# Groundwater Application Review Summary Form

Application # G- 18885\_\_\_\_\_

GW Reviewer \_\_\_Karl Wozniak\_\_\_\_\_ Date Review Completed: \_2/18/2020\_\_\_\_\_

**A. GENERAL INFORMATION:** Applicant's Name: Burg Farm, LLC County: Yamhill

Well Statistics (section 24, 3S/4W & section 19, 3S/3W)

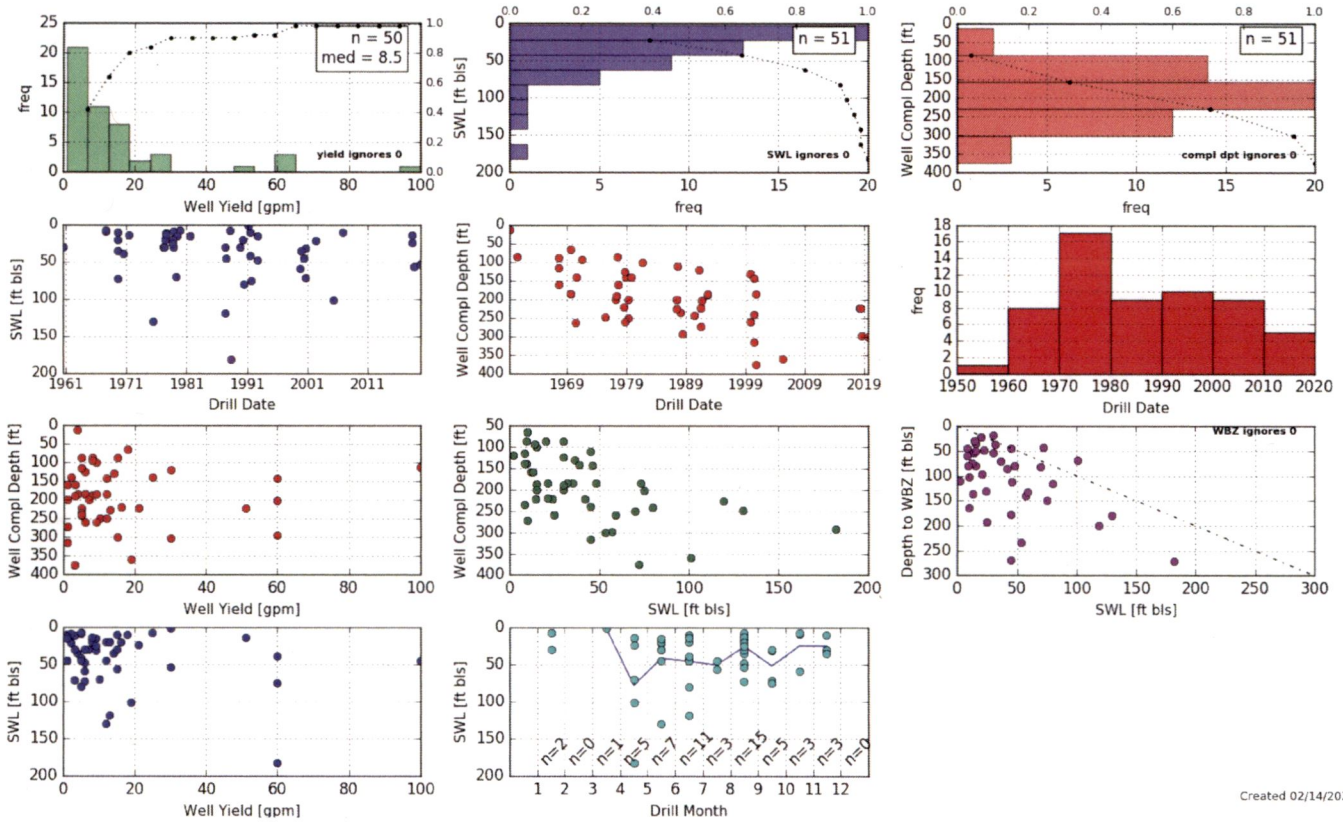
The OWRD well log database indicates a median well yield of 8.5 gpm in section 24 (3S/4W) and adjacent section 19 (3S/3W). Well yields range from 1-100 gpm (see enclosed plot) but the distribution is highly skewed toward lower values. Actual yields are likely to be lower since most of the reported yields are based on air tests which tend to overestimate yields in completed wells. Also, the above statistics do not include about ½-dozen wells that found no usable quantities of water. The applicant is requesting a maximum rate of 0.0668 cfs (30 gpm), which is high relative to the median well yield in the

Water-Level Trends in Nearby Wells

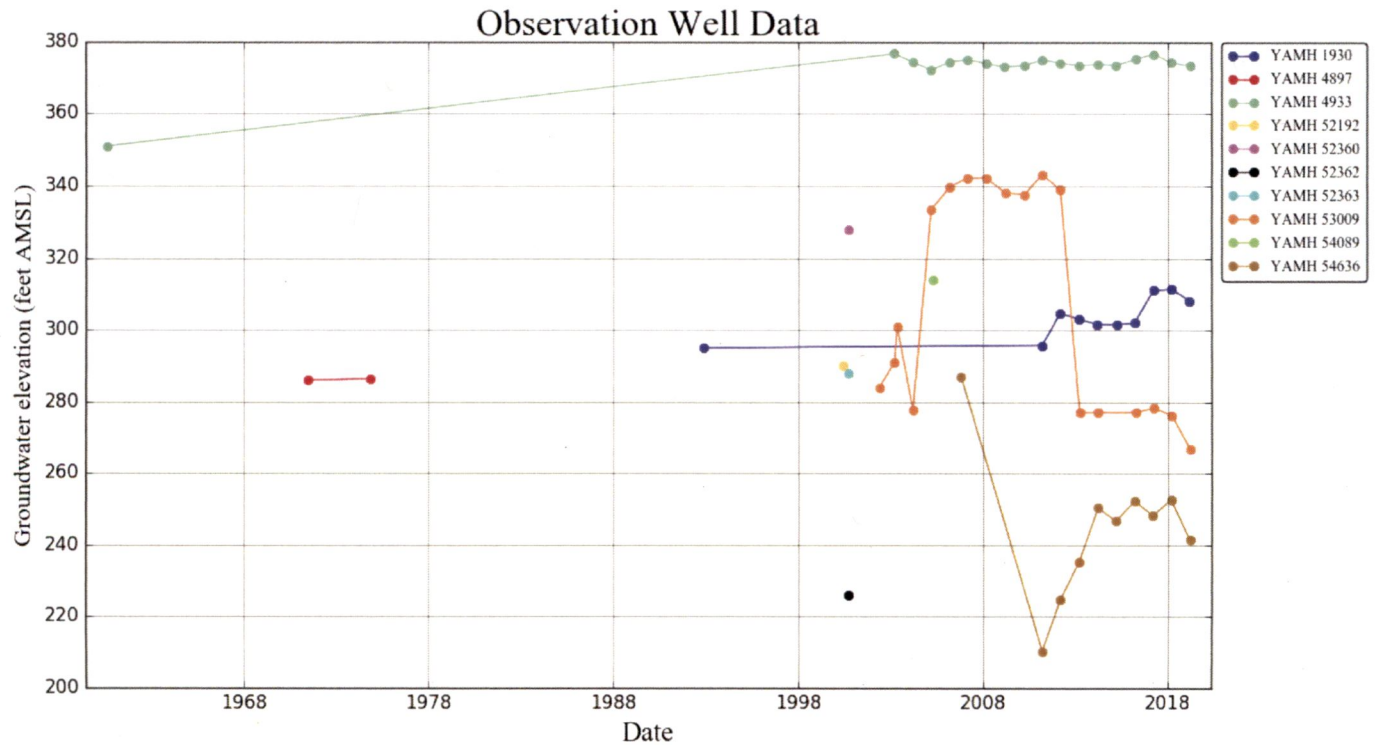
Limited water-level data in the area show no evidence of long-term declines.
